CITY PLANNING COMMISSION

- APPLICATION:
1. Environmental Determination
 2. Tentative Map (P84-020)
 3. Variance to create lots substandard in depth (Sec. 3-E-19)
 4. Subdivision Modification to create lots substandard in depth (Sub. Ord. Sec. 40.322 (c))
 5. Subdivision Modification to create a street off-set less than 120' (Sub. Ord. Sec. 40.306)

LOCATION: South side of Ehrhardt Avenue opposite La Sombra Way

TENTATIVE MAP SUNRISE VALLEY

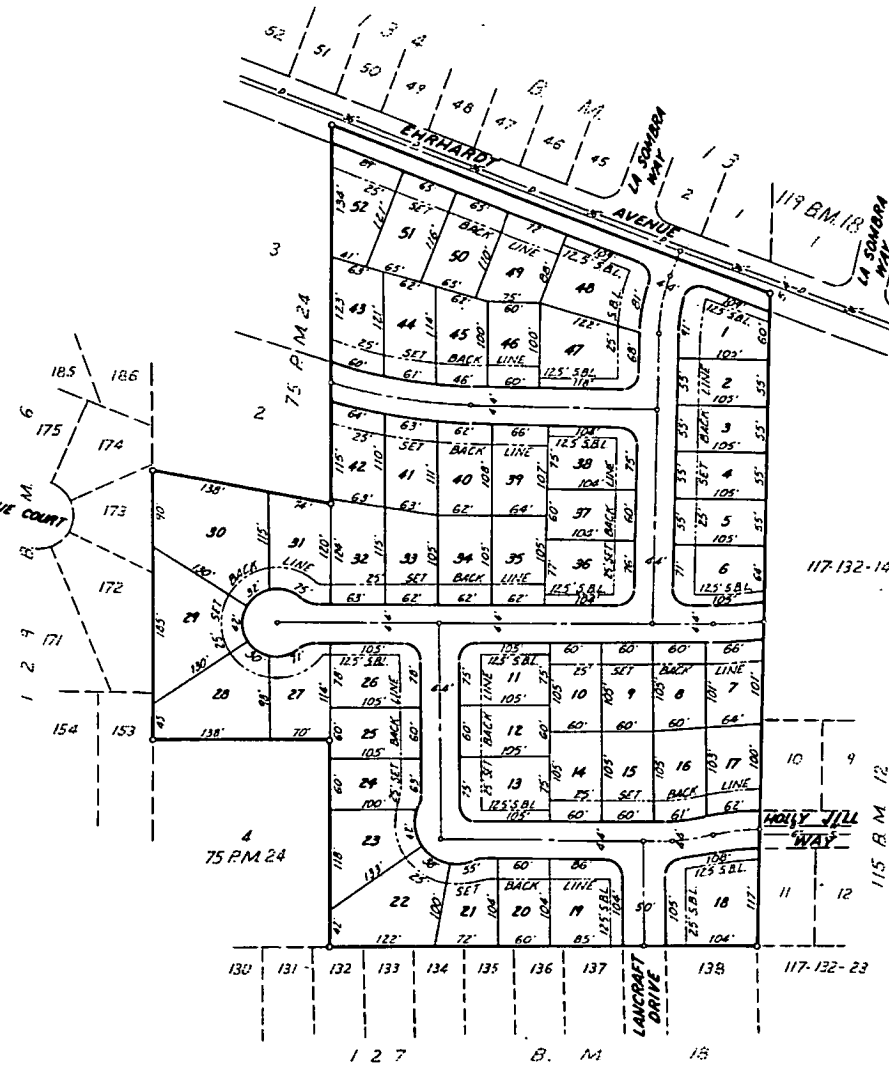
1. The subject site is located in an area that is developing primarily with standard single family residences. The previous approval provided stub streets for the future residential development of parcels east and west of the subject site (see Exhibit A). Subsequent to approval in 1978, the parcel to the west was split into four parcels. One parcel was acquired by the applicant and incorporated into the subject site. A second parcel was purchased and developed as a church site. A third parcel has been developed as a children's day care center (see Exhibit B). Therefore, the stub street to the west is no longer necessary. Staff recommends a redesign to eliminate the proposed stub street to the west.

2. A subdivision modification has been requested to create a street centerline offset of less than 120 feet as required by the Subdivision Ordinance. The Traffic Engineer has no objection to this request and the Subdivision Review Committee recommended approval of the subdivision modification. Staff, therefore, supports the request.

3. A variance/subdivision modification to create a lot less than 100 feet in depth has also been requested (Lot 49). Staff and the Subdivision Review Committee recommend approval of the request. The irregular shape of the site made it difficult to achieve standard lot dimensions throughout the site. Finally, the lot will be similar in character and appearance to the rest of the subdivision.

5. The project achieves 62% north/south lot orientation. In order to achieve the 80% north/south lot and/or unit orientation goal of the General Plan, the map has been so conditioned that solar access will be achieved through a combination of lot and unit orientation. Compliance will be reviewed as building permits are issued.

- f. Redesign the map to eliminate the stub street to the west.
